Service Bulletin 484

Affected Models	.Daytona 675, Daytona 675R, Daytona 675 ABS, Daytona 675R ABS
VIN Range	.VIN 564948 to VIN 586561
Markets	.Ali
Subject	Exhaust Butterfly Valve Cables

We have identified a need to replace the exhaust butterfly valve cables on the above models. Dealers are requested to remove and replace the exhaust butterfly valve cables.

- 1. Arrow, before adjustment
- 2. Butterfly valve stop
- 3. Closing cable

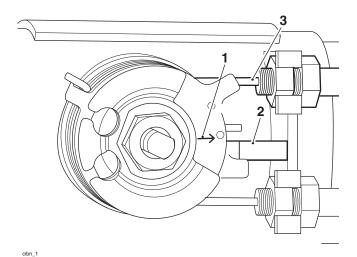
- The closing cable is uppermost and has the silver coloured end.
- 6. Adjust the closing cable adjuster until the arrow on the butterfly valve pulley is aligned with the upper edge of the butterfly valve stop.

- 1. Threaded area
- 2. Adjusters, control plate removed for clarity

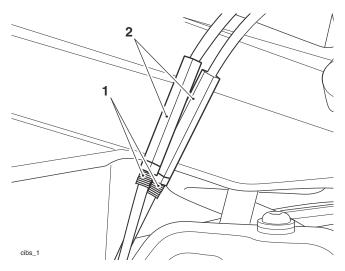
7. With the arrow aligned with the upper edge of the butterfly valve stop, adjust the opening cable until it has the same amount of thread showing as the closing cable.
